COUNCIL ASSESSMENT REPORT

HUNTER AND CENTRAL COAST REGIONAL PLANNING PANEL

PANEL REFERENCE & DA NUMBER	PAN/463683 – DA/1389/2024		
PROPOSAL	Coastal Protection Works (Section C)		
ADDRESS	3-33 Pacific Street, Wamberal 23A-25 Ocean View Drive, Wamberal Ph175 Council Land and Road Reserve		
LOTS AND OWNERS	Lot	Plan	Address
	PACIFIC STREET		
	PH175 (on Wamberal Beach)		TBC
	19	DP 8854	3 Pacific Street
	18	DP 8854	5 Pacific Street
	16 & 17	DP 8854	9 Pacific Street
	15	DP 8854	11 Pacific Street
	14	DP 8854	13 Pacific Street
	Lot 0 CP	SP 8735	15 Pacific Street
	12	DP 8854	17 Pacific Street
	11	DP 8854	19 Pacific Street
	10	DP 8854	21 Pacific Street
	9	DP 342613	23 Pacific Street
	9A	DP 342613	23A Pacific Street
	Lot 0 CP	SP 5039	25 Pacific Street
	6	DP 8854	29 Pacific Street
	5	DP 8854	31 Pacific Street
	4	DP 8854	33 Pacific Street
	OCEAN VIEW DRIVE		
	3	DP 8854	23A Ocean View Drive
			D R Slade & E A Slade

TO APPLCIANT	
PREPARED BY	Henry Burnett – Director, DFP Planning Natasha Bartley – Principal Planner, DFP Planning
DATE OF REPORT	20 November 2025

Figure 9 – Proposed Terminal Structure Section C – 29 Pacific Street – 25 Ocean View Drive

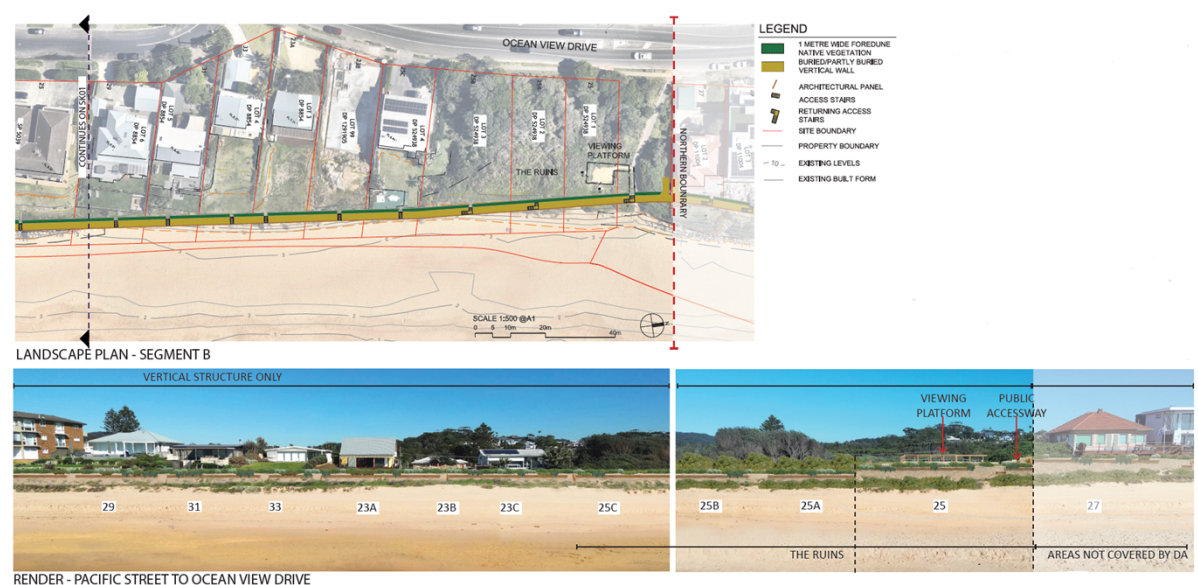
While end treatment returns are proposed at both ends to account for timing conflicts in the construction of the adjoining Section B and the exclusion of 1 Pacific Street their design is not detailed.

Figure 10 – 1 Tier Design

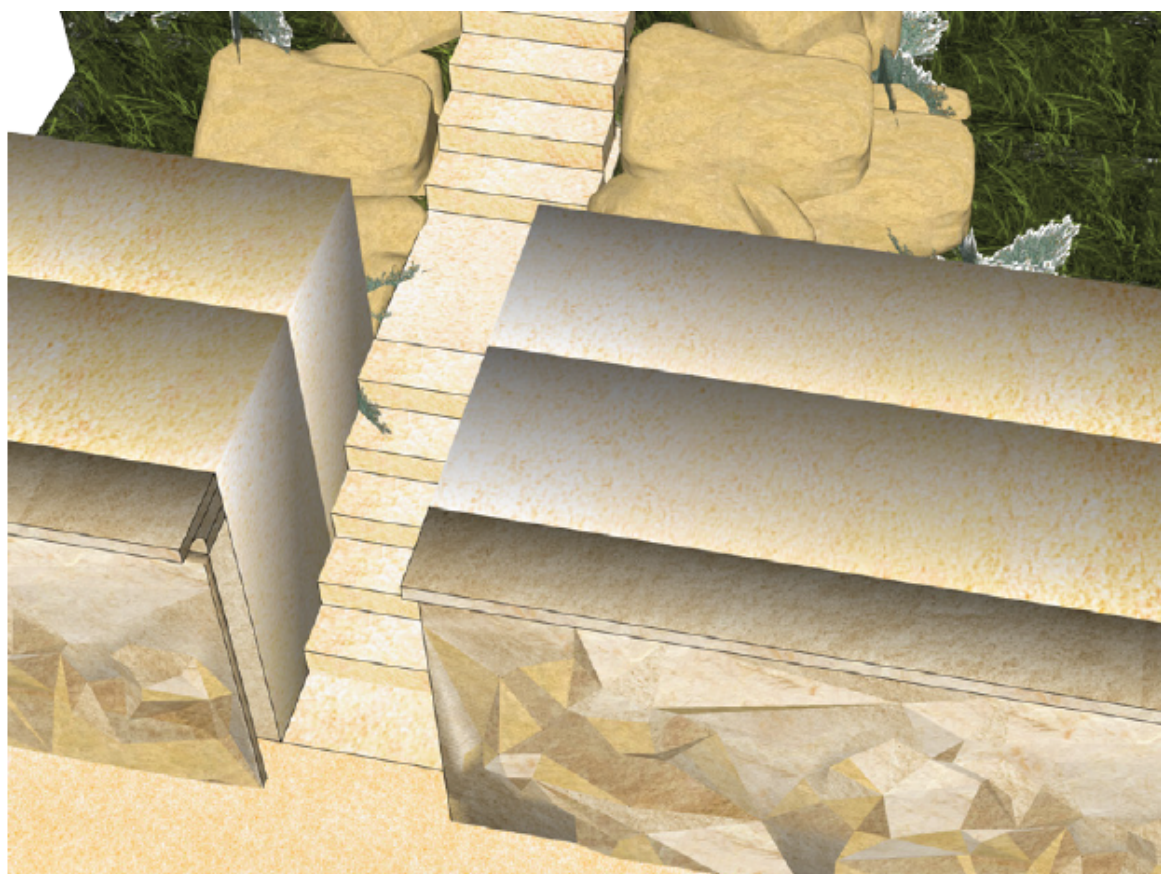
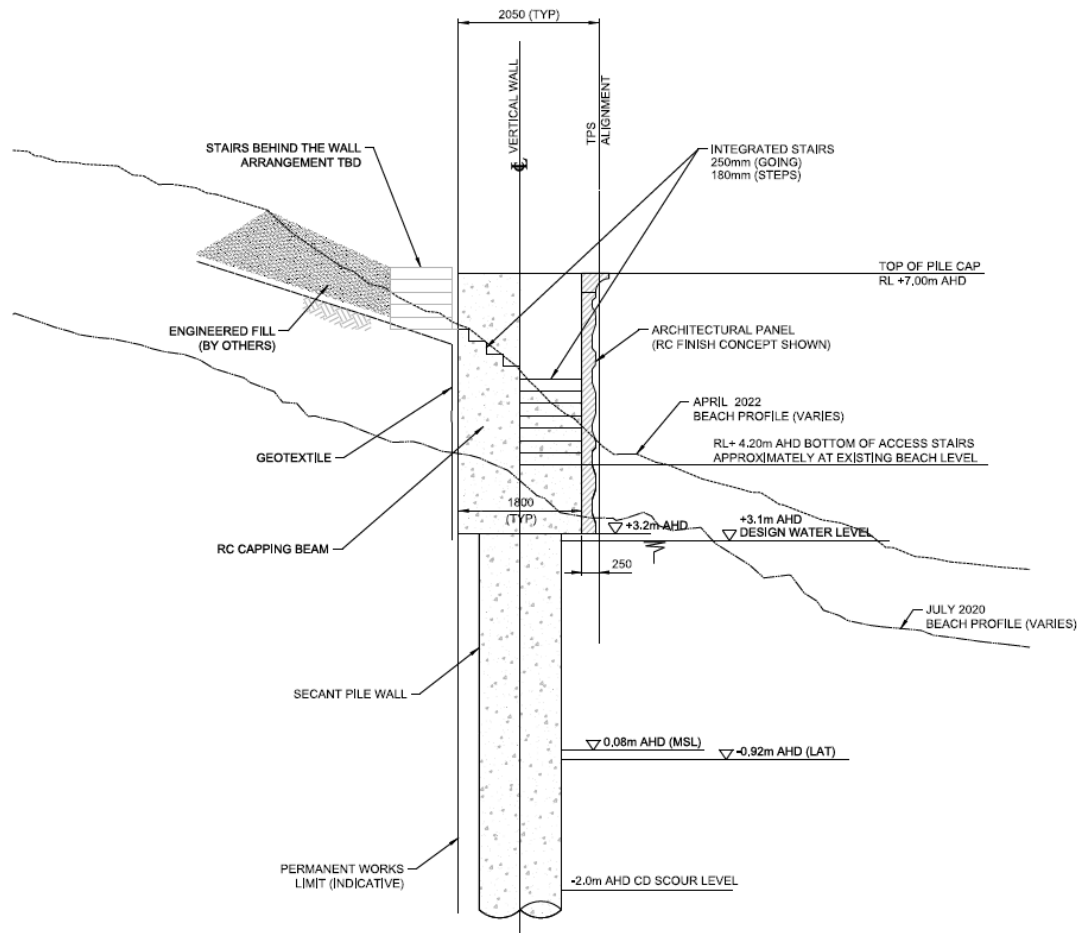
The Section C terminal protection structure bottom tier interfacing with Wamberal Beach is a 3.8m high precast concrete panel including a waver deflector.

The vertical extent of the Section C terminal protection structure visible from Wamberal Beach varies depending on the existing sand level. The submitted documentation provides landscape renders only of the finished sand level and does not provide sectional drawings to address the varying level conditions at each property and the associated the extent of cut and fill required (whether behind or in-front of the terminal protection structure).

The submitted engineering drawings provide a typical sectional detail of the terminal protection structure. An excerpt of the detail for the 1 Tier Design is provided in **Figure 11**. The detail demonstrates the potential for fill required behind the wall and the potential for significant variation in the perceived wall height depending on the sand level at each property. The engineering ‘typical detail’ has not been translated onto sectional landscape drawings that address the level conditions at each property (or a sampling of properties).
